UNITED STATES PATENT AND TRADEMARK OFFICE

APPLICATION NO.	FILING DATE	FIRST NAMED INVENTOR	ATTORNEY DOCKET NO.	CONFIRMATION NO.
09/515,285	02/29/2000	Toshiya Fukuhisa	NAK1-BK00	2072

Office Action Summary

DETAILED ACTION

FIG. 1

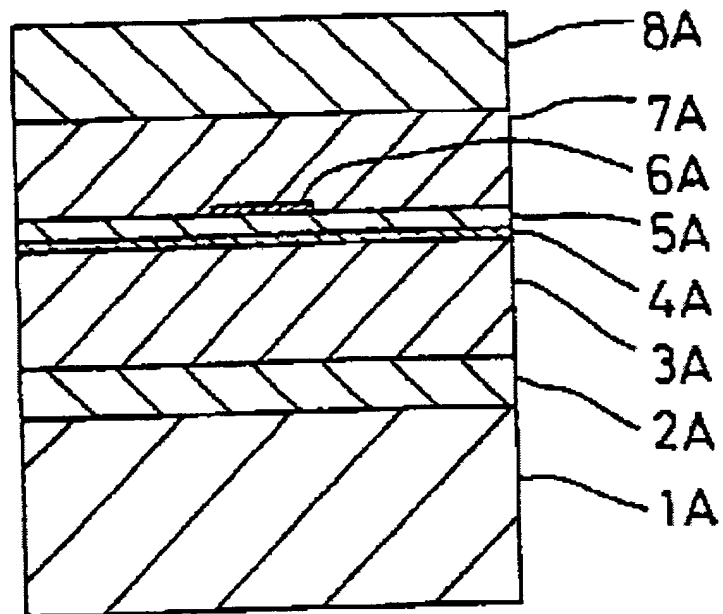
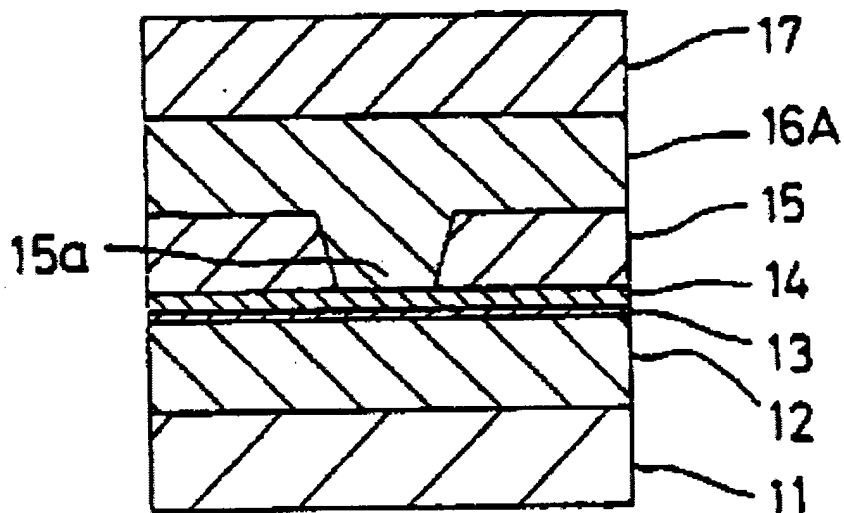
With respect to claim 1, Naito et al discloses a method for forming semiconductor laser device comprises n-type semiconductor substrate (1A), n-type cladding (3A), an active layer (4A), a p-type cladding (5A), a p-type buried cladding (7A), a current blocking (15), note cols. 1-16, see figs 1-9.

FIG. 1

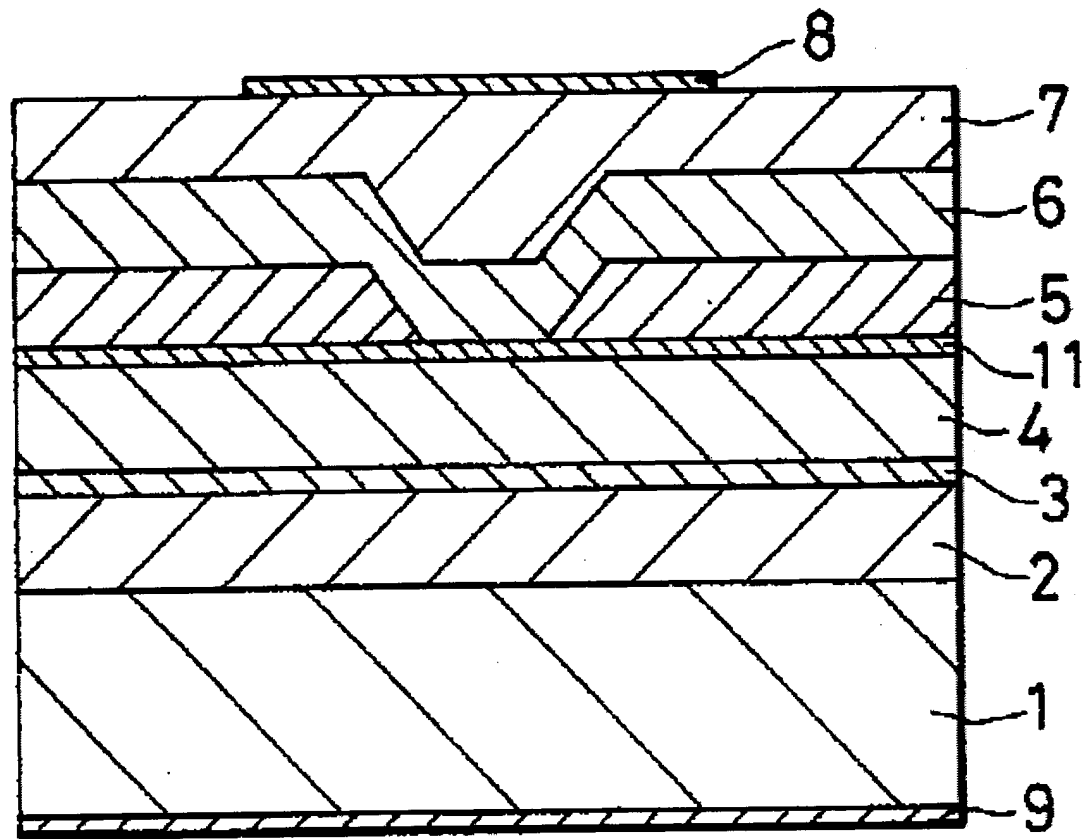
With respect to claim 11, Naito et al discussed all above except for the current blocking interface between p-type cladding and p-type buried cladding. Whereas Yoshizawa discussed about the current blocking interface between p-type cladding and p-type buried cladding, note col. 3, see fig 1. For the benefit of the current blocking interface between p-type cladding and p-type buried cladding, it would have been obvious to one having ordinary skill in the art at the time the invention was made to provide Naito with the current blocking interface between p-type cladding and p-type buried cladding as taught or suggested by Yoshizawa.

With respect to claim 12, Naito et al discussed all above except for the interjacent layer being positioned between the current blocking and p-type cladding. Whereas Yoshizawa discussed about the interjacent layer (11) being positioned between the current blocking (5) and p-type cladding (4), note col. 3 , see fig. 1. For the benefit the interjacent layer being positioned between the current blocking and p-type cladding, it would have been obvious to one having ordinary skill in the art at the time the invention was made to provide Naito with the interjacent layer being positioned between the current blocking and p-type cladding as taught or suggested by Yoshizawa.

With respect to claims 35 and 36, Naito et al discussed all above except for the interface between the p-type cladding base layer and the p-type buried cladding layer. Whereas Yoshizawa discussed about the interface between the p-type cladding base layer and the p-type buried cladding layer note col. 3-4, see fig. 1. For the benefit of the interface between the p-type cladding base layer and the p-type buried cladding layer, it would have been obvious to one
